RENAUD BROS., INC.

Brattlboro BRO 1442 (35)

Temporary Bridge Re-submittal

SOUTHBOUND MOVEMENT
TRUCK FOOTPRINT
FRONT TIRE TRACK
REAR TIRE TRACK
REGINA VISTA (PRIVATE ROAD)
R=5'
61° 47' 2"
TEMPORARY BRIDGE
DETOUR
3+00
2+00
R = 5.0'
TOWN R.O.W.
SUNSET LAKE ROAD (TH 12)
1+00
102+00
103+00
26° 26' 3"
104+00
4+00
4+37
105+00
TO DUMMERSTON
106+00
TOWN R.O.W.

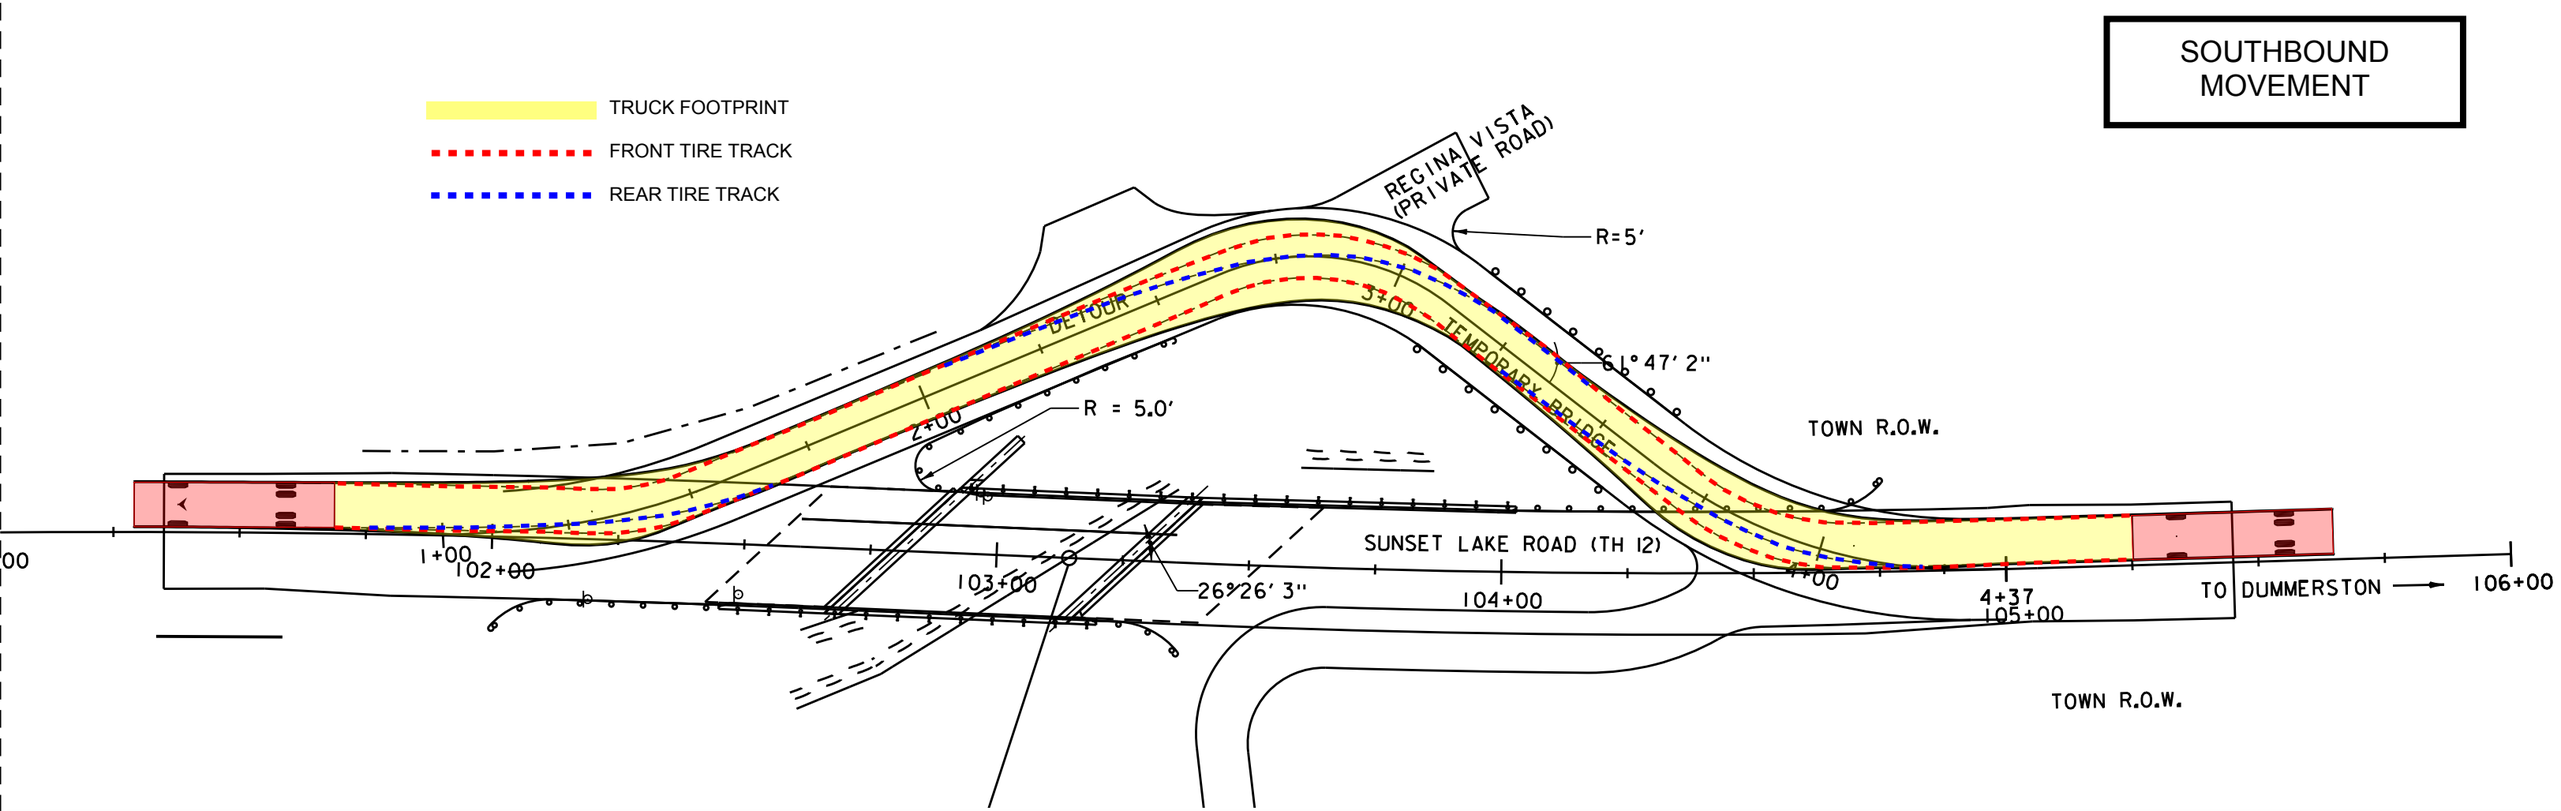
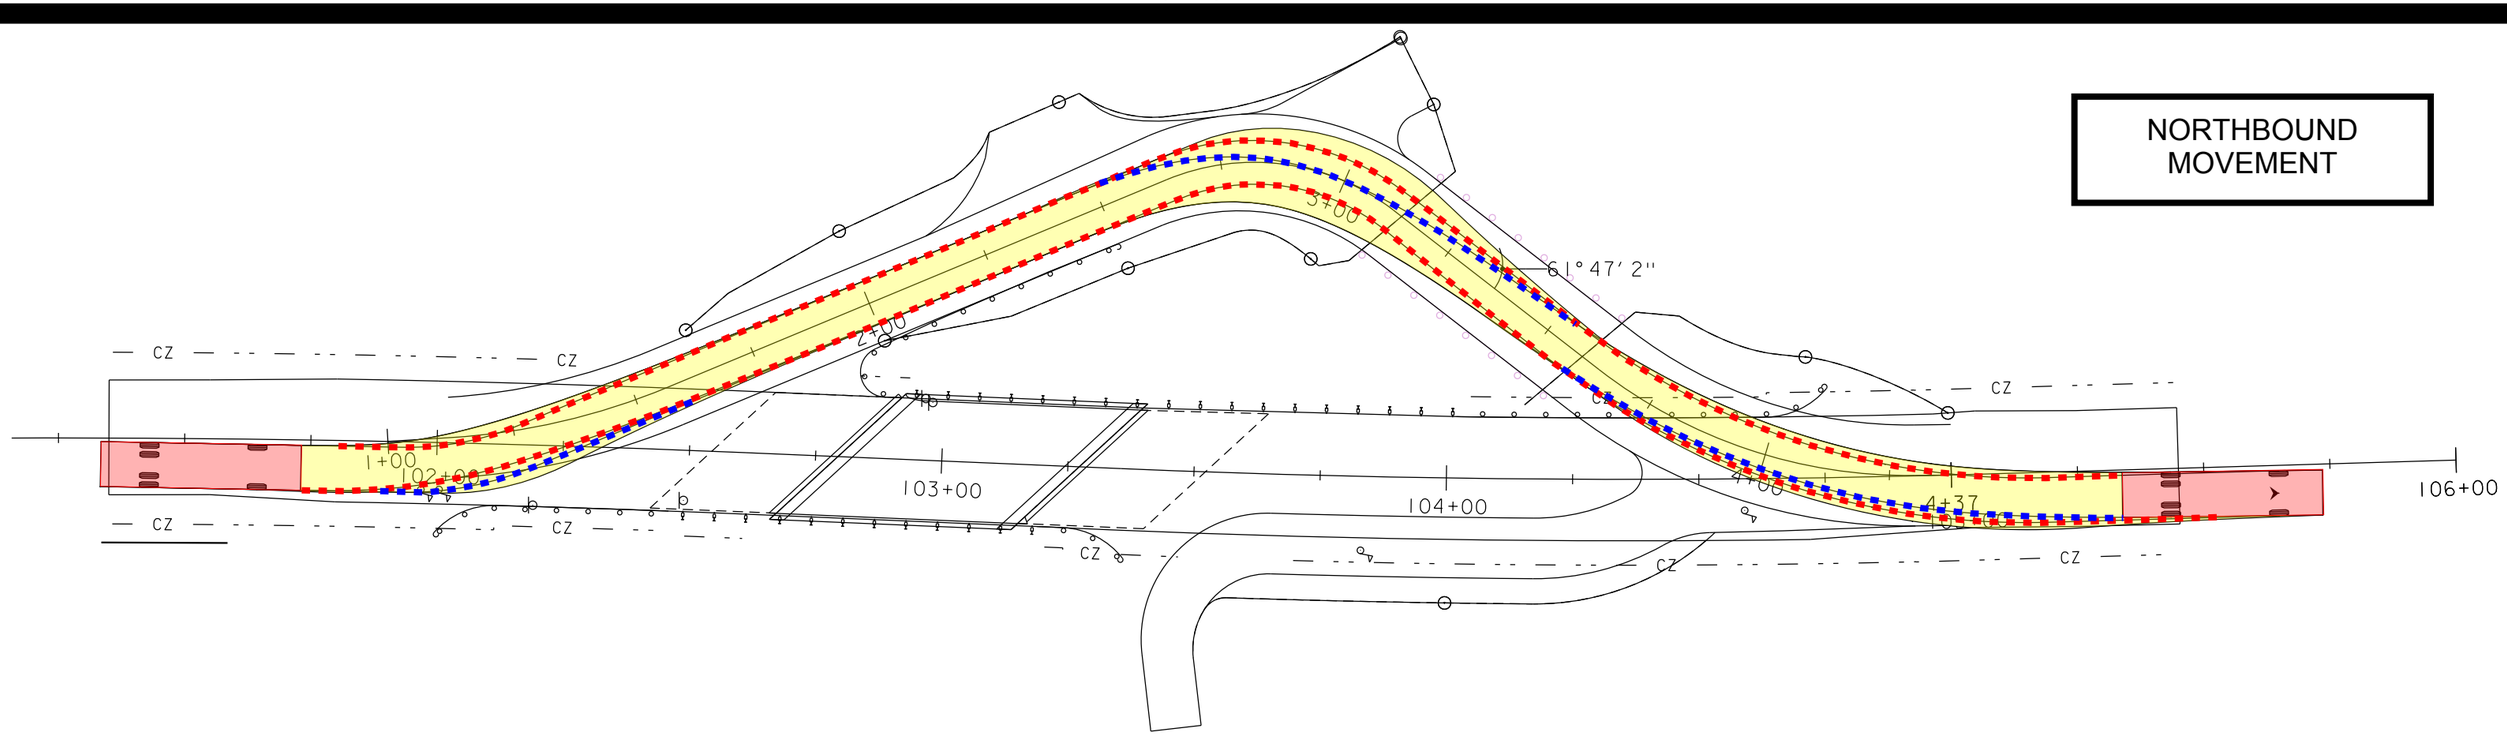
The ladder truck turning movements have been reviewed and it looks like it should be capable of maneuvering through the detour, as designed.

Based on the attached information provided by Michael Bucossi, Town of Brattleboro Fire Chief, we developed a model of the Brattleboro Ladder Truck in AutoTurn which we "drove" through the detour using the AutoTurn program. As noted in the attached PDF the Brattleboro Ladder Truck is capable of maneuvering through the detour.

PLAN AND PROFILE OF TEMPORARY BRIDGE, ABUTMENTS & BYPASS ROAD

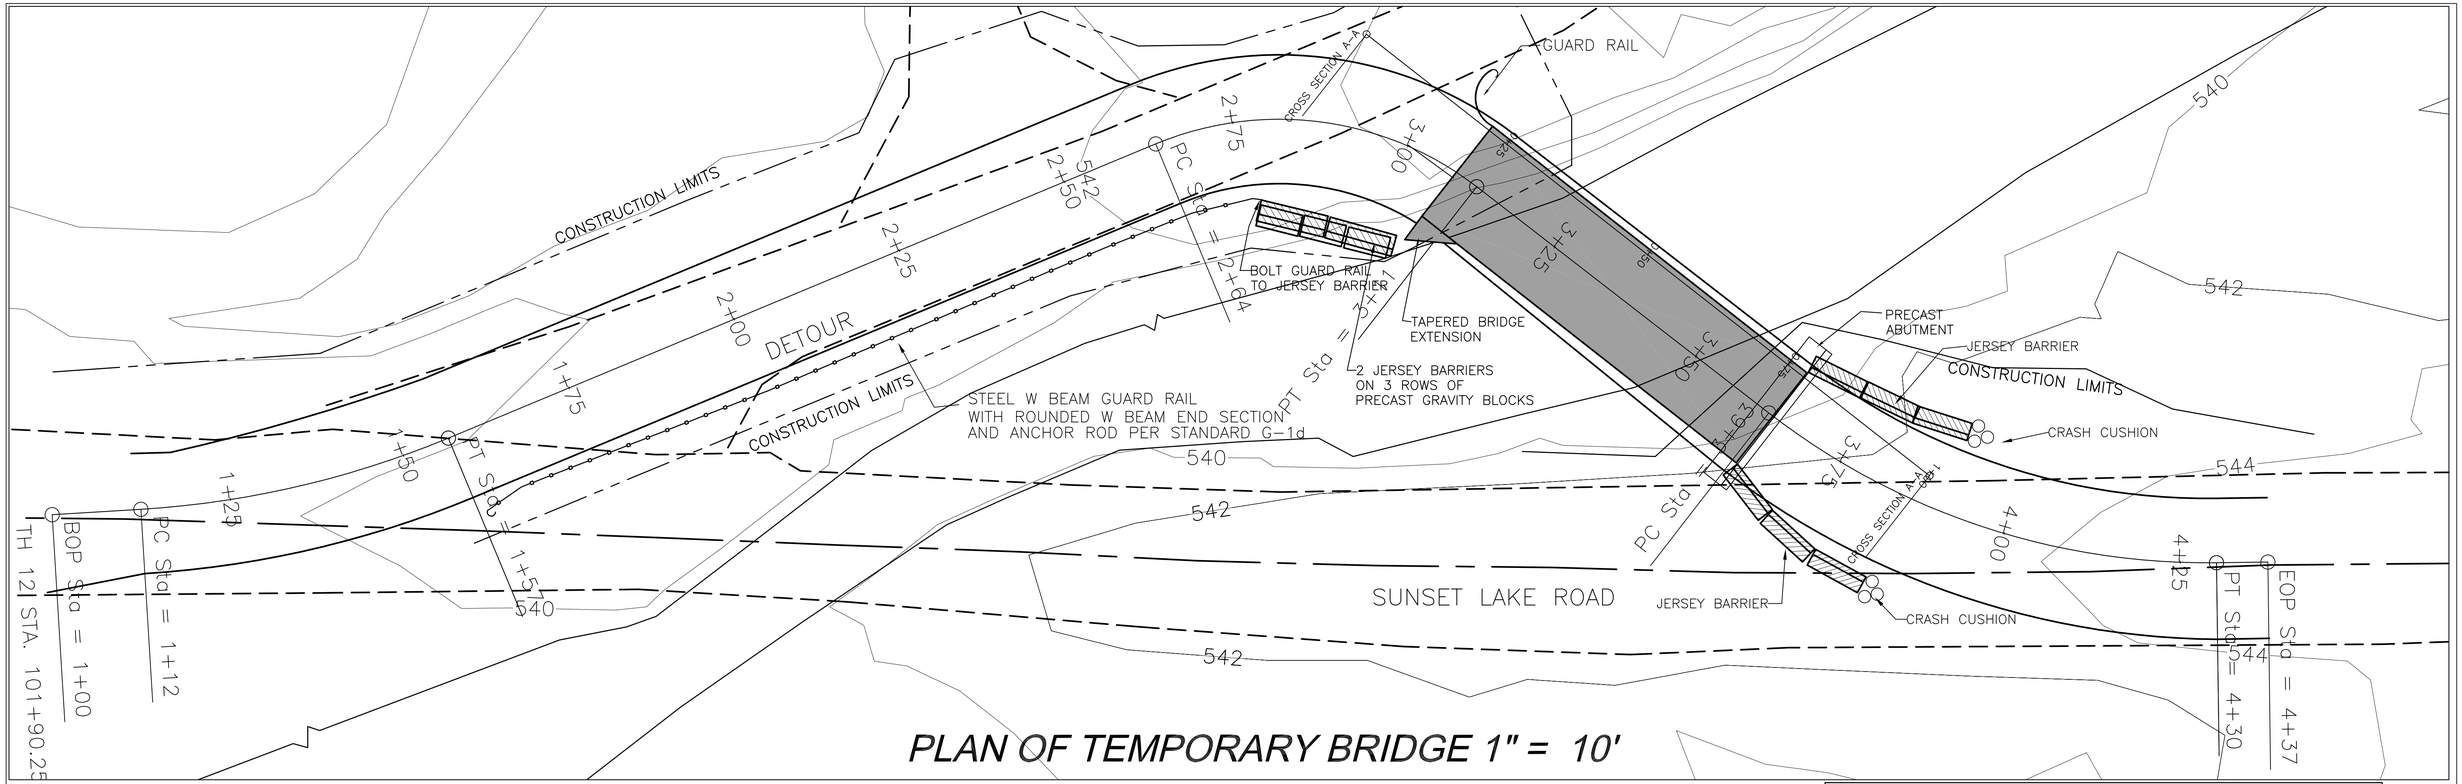
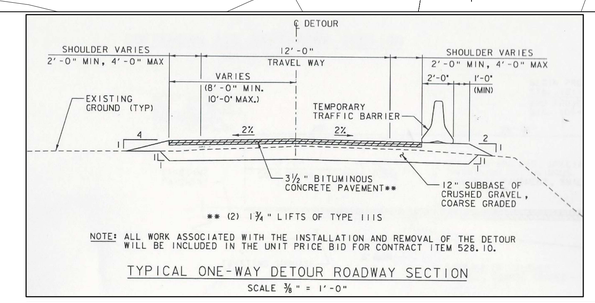
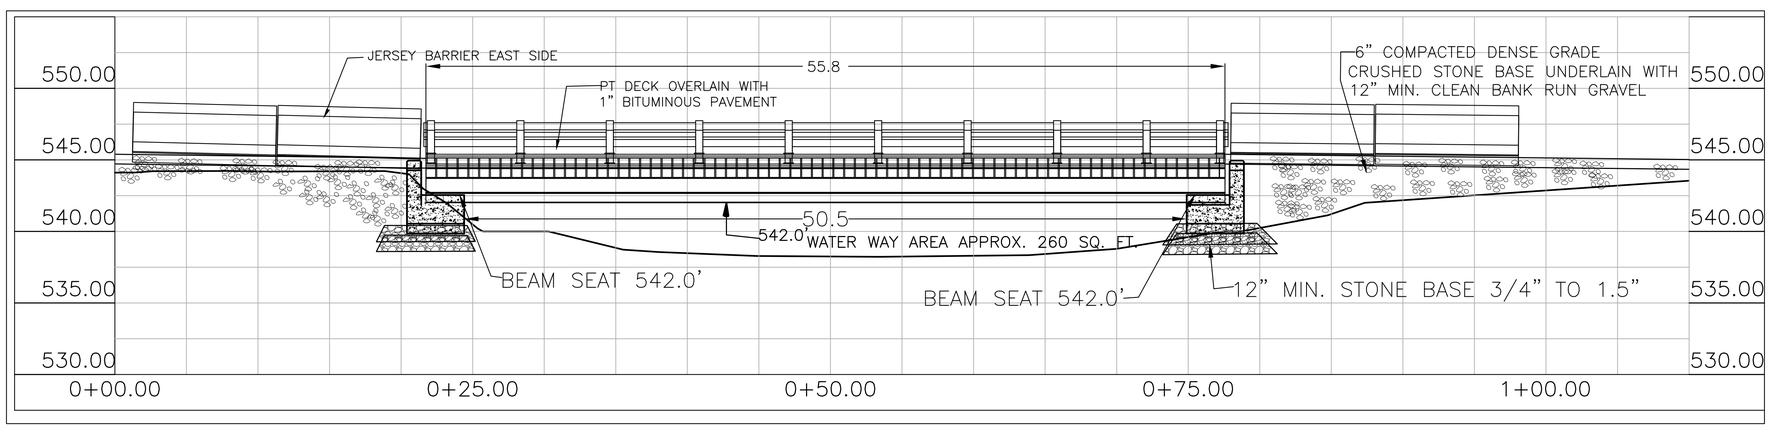
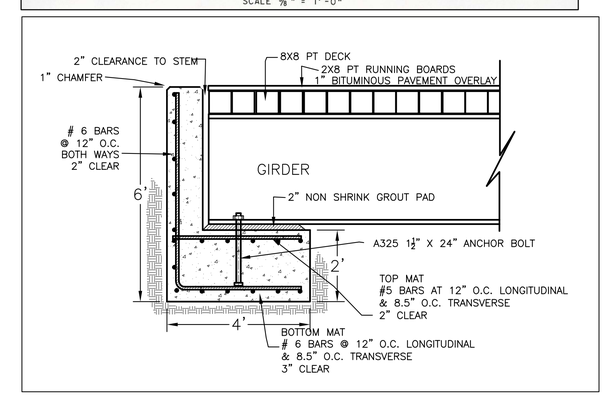
We have test run the bridge with Brattleboro Fire Department's Ladder Truck and it passed through with no trouble. We also had a school bus drive through the bridge and it passed through as well with no trouble. We recognize the South West corner is tight and will address that by adding more square footage of roadway, the plans and details are included in this submittal.

JOB NAME:	BRATTLEBORO
JOB NO:	BRO 1442(35)
SHEET NAME:	RAIL ATTACHMENT DETAIL

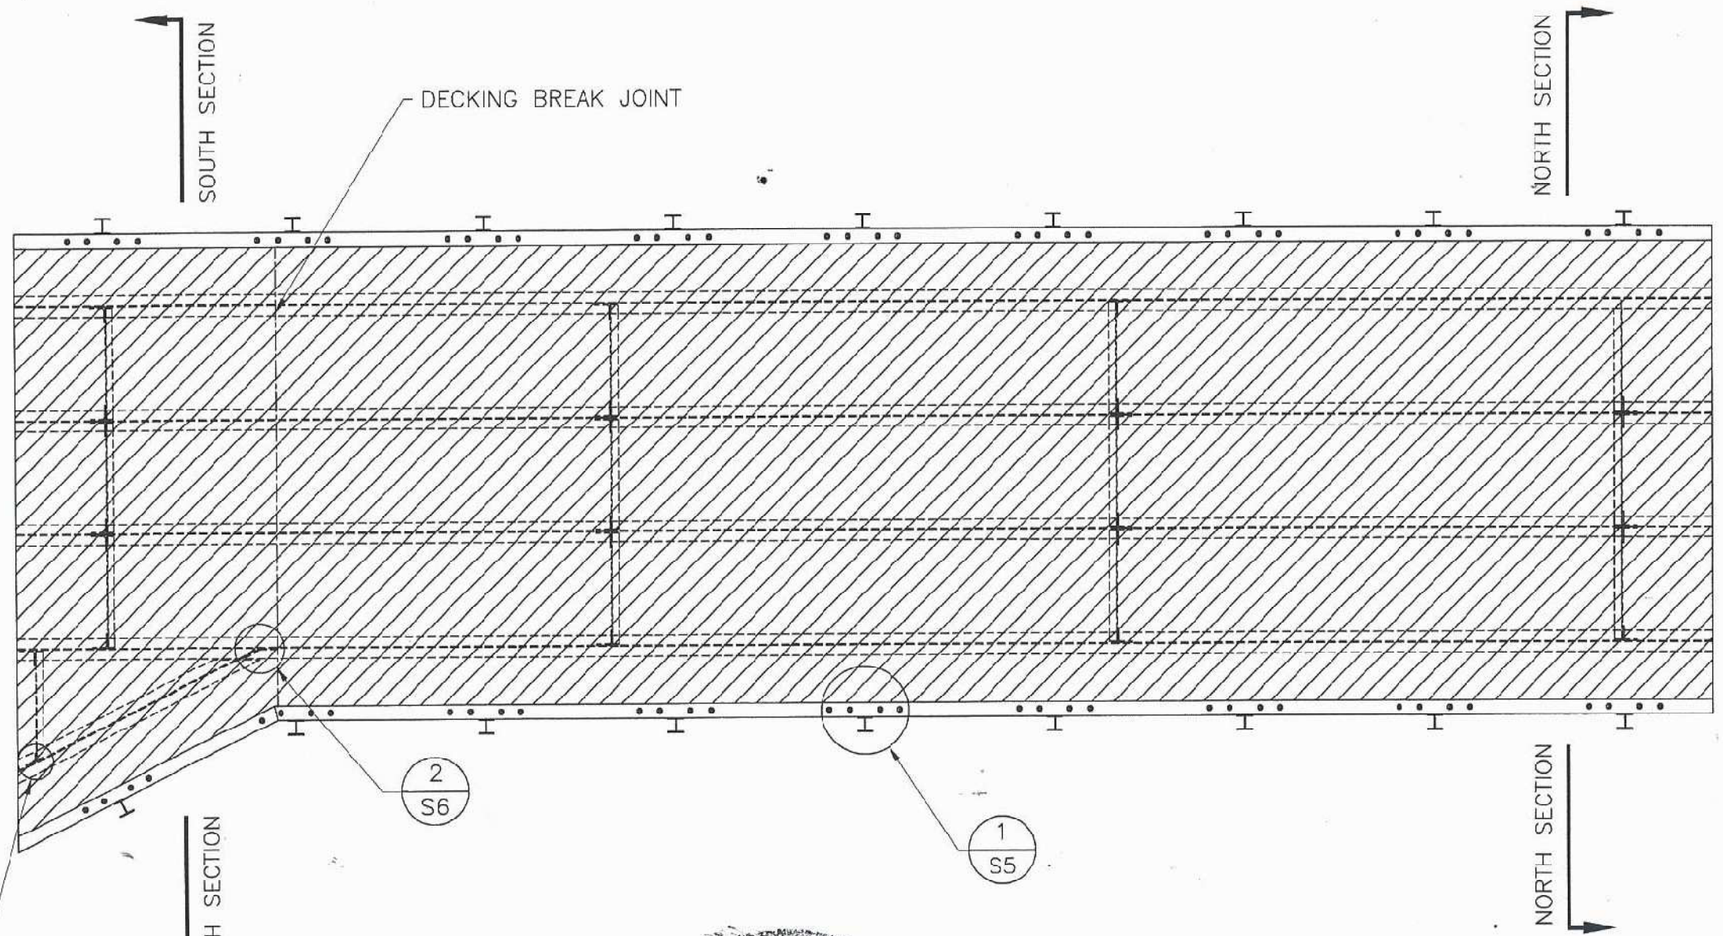
REV.		
NO.	DATE	COMMENTS
1	5/5/14	WIDEN APPROACH

JOB NAME:	BRATTLEBORO
JCB NO:	BRC 1442(35)
SHEET NAME:	TEMP BRIDGE ELEVATION

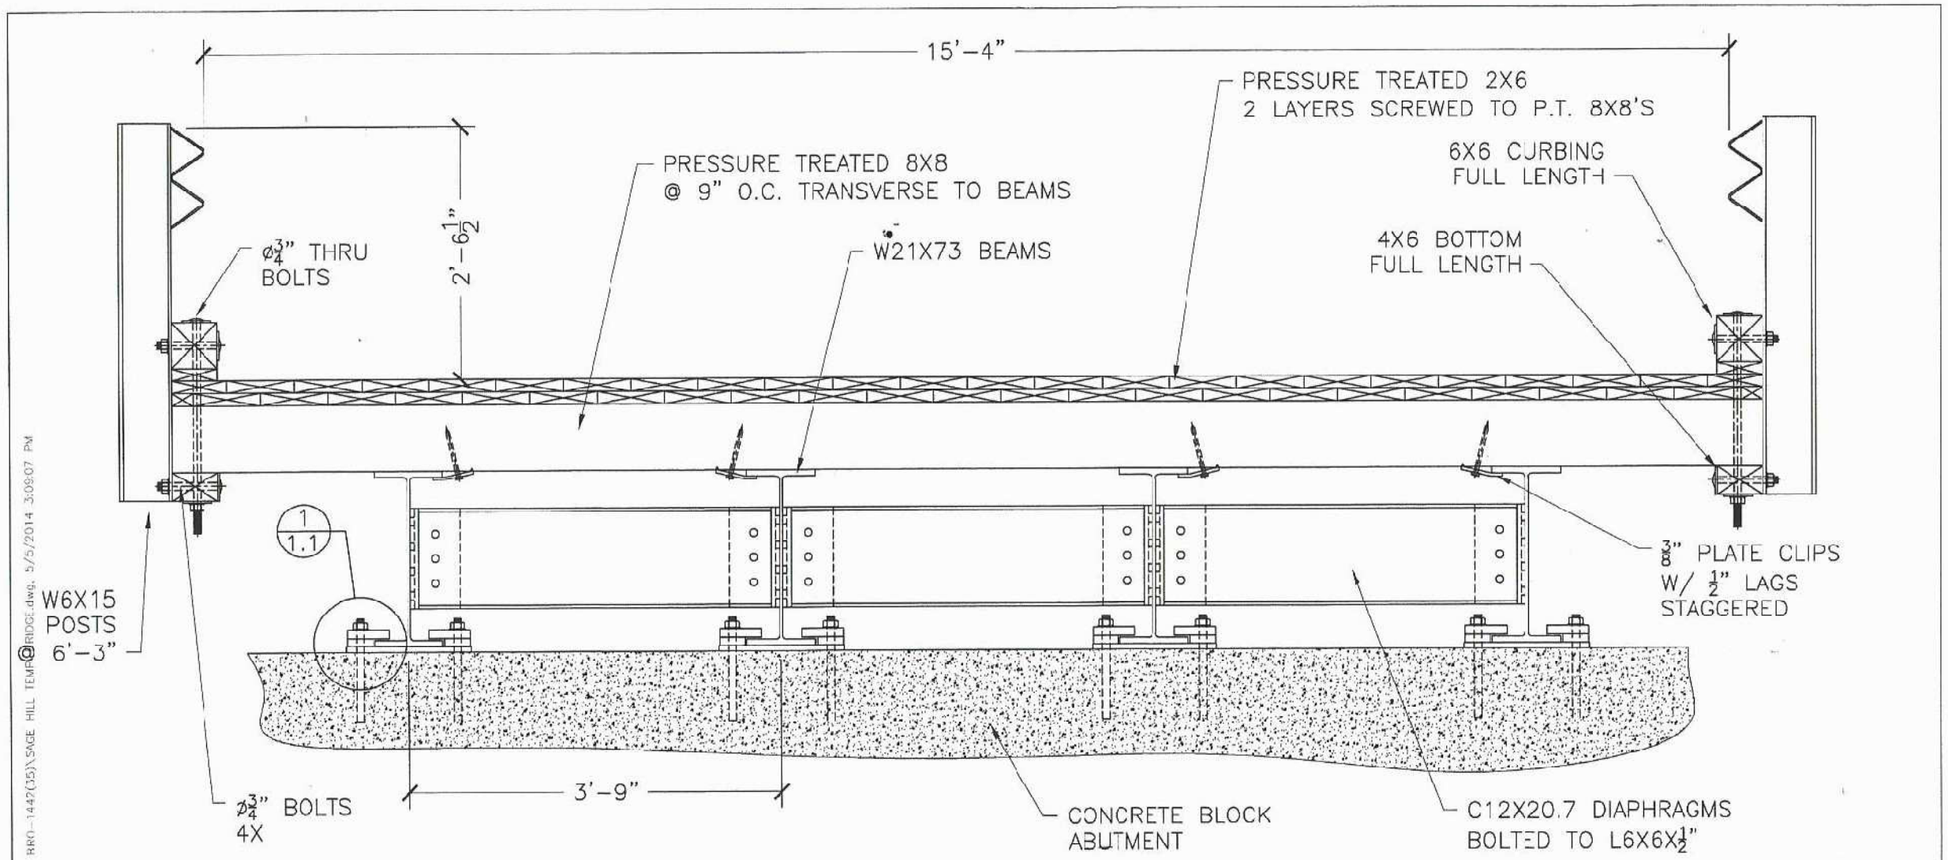
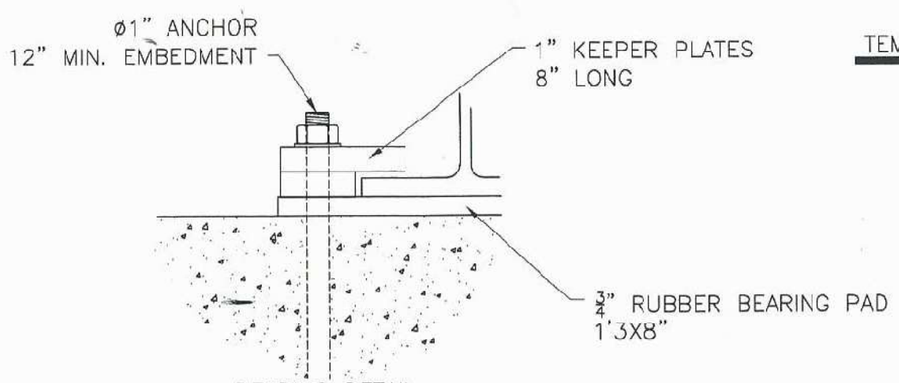
REV.		
NO.	DATE	COMMENTS
1	5/5/14	WIDEN APPROACH
